CLASS II MODIFICATION 8.2.2019
• ADD TRELLIS BETWEEN III & VI-S

ATLANTIC CROSSING

BLDG VI ELEVATIONS

A6.4

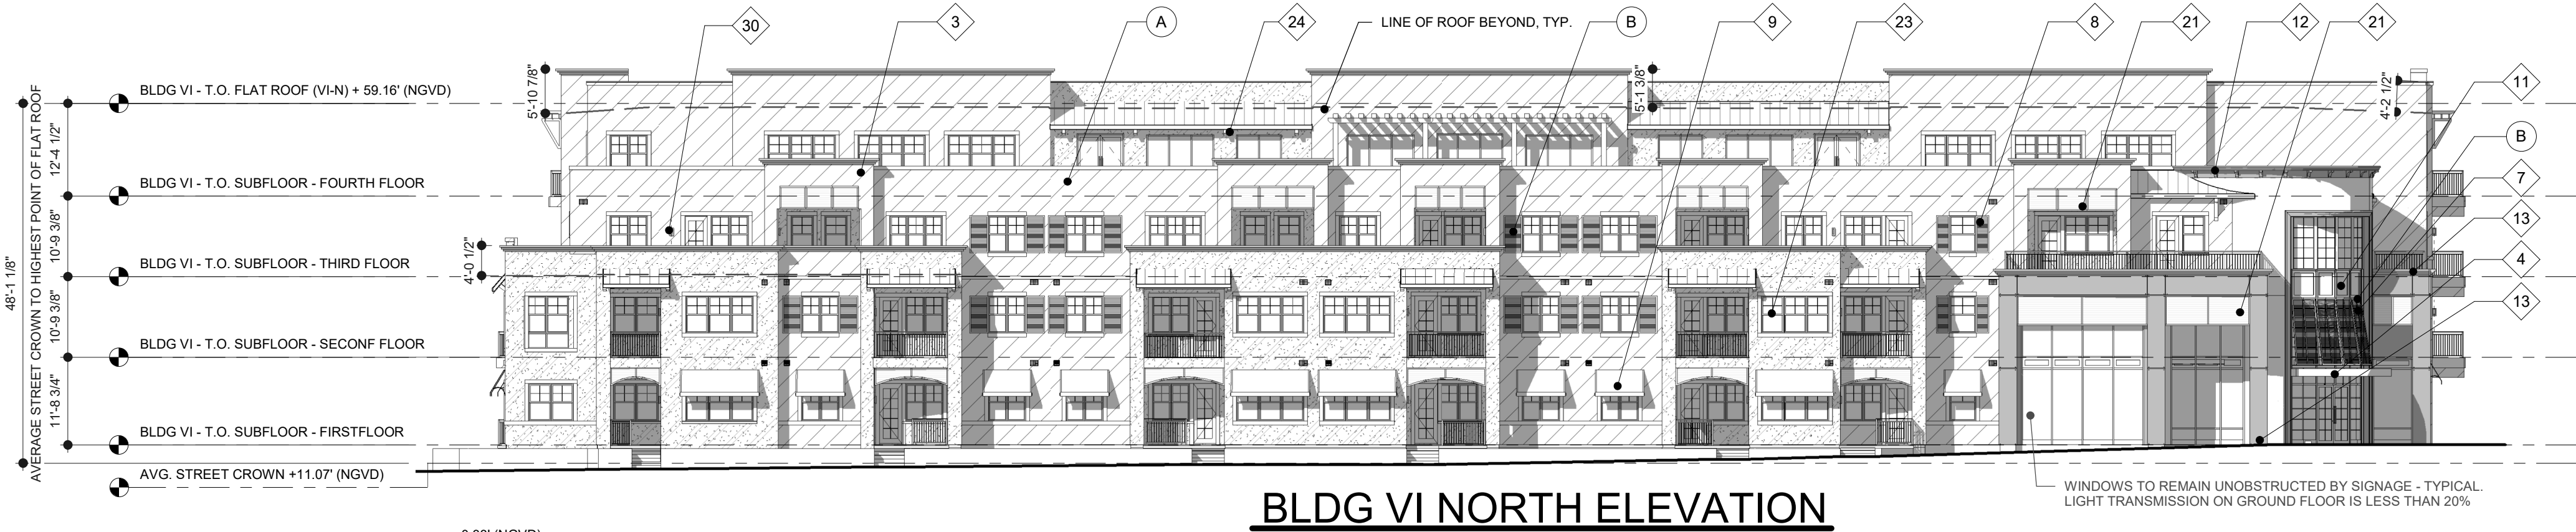
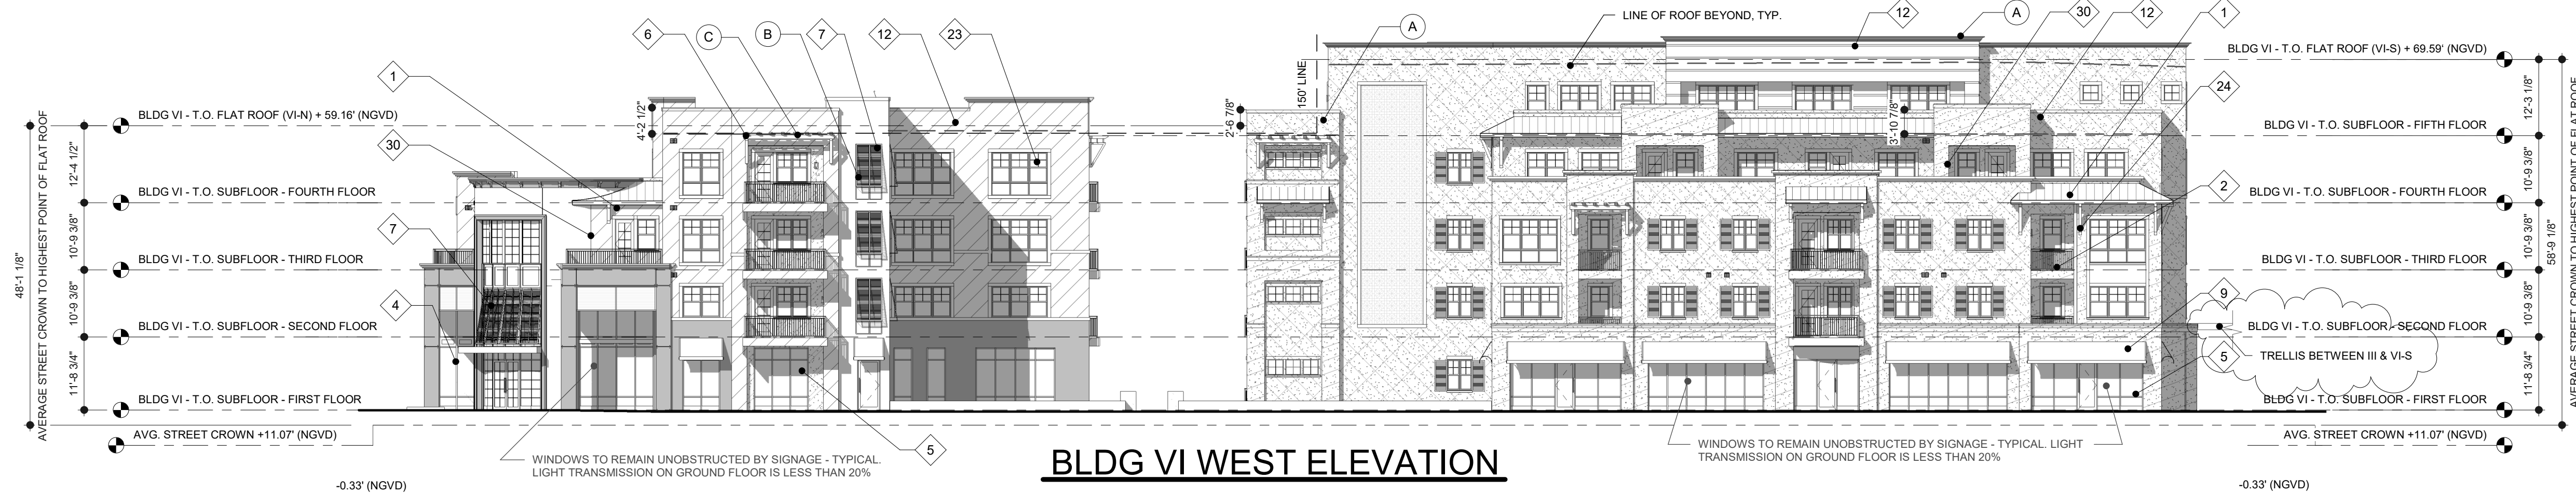
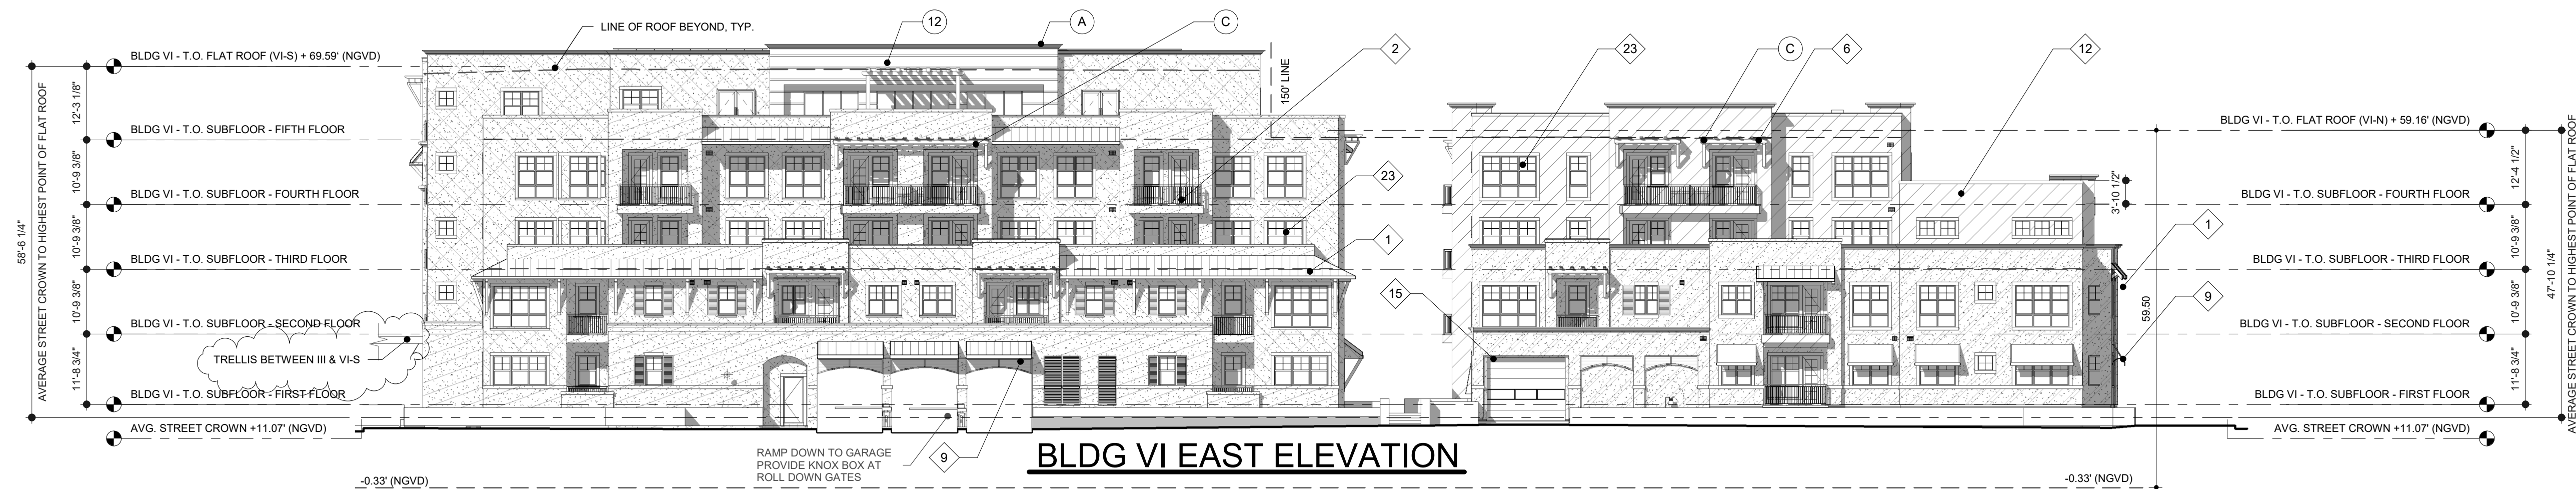
RESPONSE TO 2.12.14 STAFF COMMENTS
• WINDOWS OF THE BUSINESSES AND OFFICES REMAIN UNOBSTRUCTED BY SIGNAGE
• LIGHT TRANSMISSION FOR GROUND FLOOR GLASS AREA TO BE NO GREATER THAN 20%
• KNOX BOXES TO BE PROVIDED AT ROLL DOWN GATES
• ADJUSTED METAL AWNINGS AND ADDED MORE SHUTTERS

SETTLEMENT MODIFICATION 4.21.2017
• RELOCATED ENTRY TO PARKING GARAGE
• ADJUST EAST AND SOUTH DUE TO PARKING GARAGE ENTRY RELOCATION

ARCHITECTURAL ELEVATION REVISIONS 7.19.2018
GENERALLY REVISE ELEVATIONS TO BE MORE CONSISTENT WITH MASONRY MODERN, INCLUDING:

- STRENGTHENING PEDESTRIAN SCALE OF ENTRY TO LEASING (NORTHWEST CORNER)
- ENHANCED HORIZONTAL DETAILING AT BASE - ADDED ROOF FORMS, CONSOLIDATED COLOR, MINIMIZED TALL SLENDER VERTICAL FORMS
- ENHANCE DETAILING AT BUILDING CORNERS
